Western Harbour Tunnel and Warringah Freeway Upgrade

State Significant Infrastructure Assessment SSI 8863

Published by the NSW Department of Planning, Industry and Environment

Figure 29 | Falcon Street diverging diamond interchange and new crossing points numbered (Source: EIS)

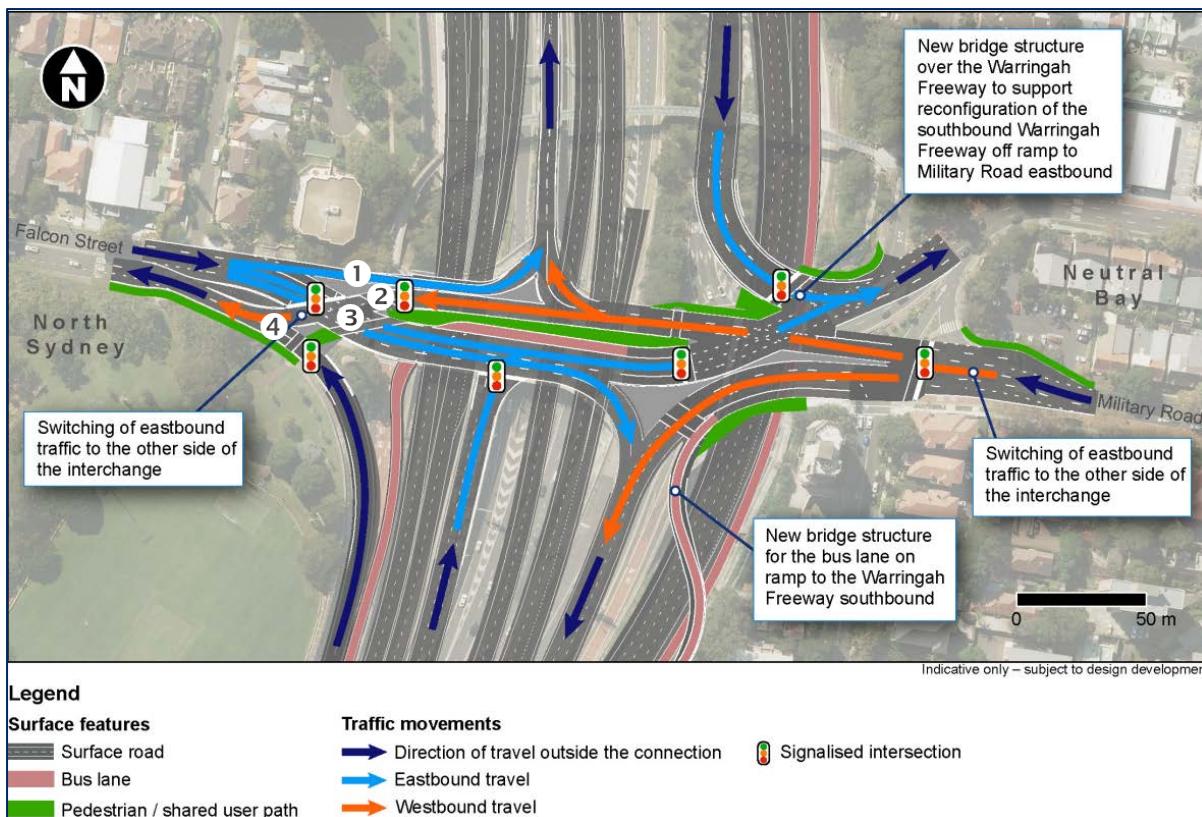
The Falcon Street intersection is proposed to be reconfigured into a diverging diamond intersection (**Figure 29**). The proposed design would increase the number of crossing points for pedestrians and cyclists, which is compounded by the removal of the existing Falcon Street underpass (linking Merlin Street North Sydney with Merlin Street at Neutral Bay). The increased crossing points would increase the time to cross this intersection. The greatest increase in crossing points is between Falcon Street North at the landing point of the Falcon Street Shared User Bridge and St Leonards Park. Active transport users are required to cross at 2 pedestrian crossings in the current configuration of the intersection. The proposed diverging diamond intersection would require active transport users to cross at 4 points.

The Department has recommended that the Proponent investigate alternative interchange crossing options as the impacts to active transport from the additional crossing points and the removal of the eastern underpass is likely to increase journey times. The investigation must consider an overpass over the interchange, a reduction in number of crossings, or priority phasing of traffic lights for pedestrians and cyclists.
